TOOL CHANGE ORDER

TOOL NUMBER TSN00548-300-C

TITLE HV BATTERY COMMUNICATION HARNESS

REV - DATE REV A - 3/18/2026

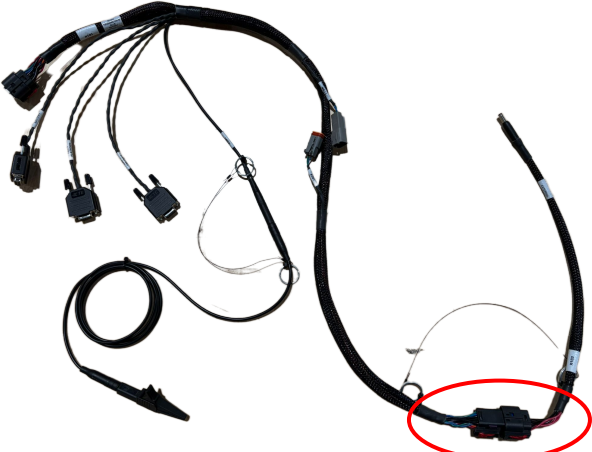
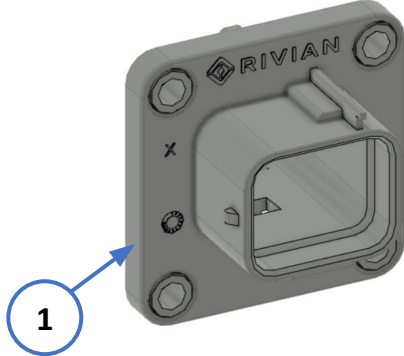
This document provides guidance to upgrade all tools in the field to the latest Revision C. This revision adds the header assembly frame from the HV Battery pack to the main Aptiv connector. Previous revisions did not have this part, which has a key feature to ensure proper connector orientation when mating the external power adapter and discharger LV stub.

1. Install PT00098697-B assembly frame to the connector labeled X201 on the Rev B comm harness in orientation shown. Frame will "click" in place once its fully seated.
2. Push red tab forward to lock frame in place
3. Apply adhesive label with updated TSN00548-300-C part number over top of existing heat shrink label
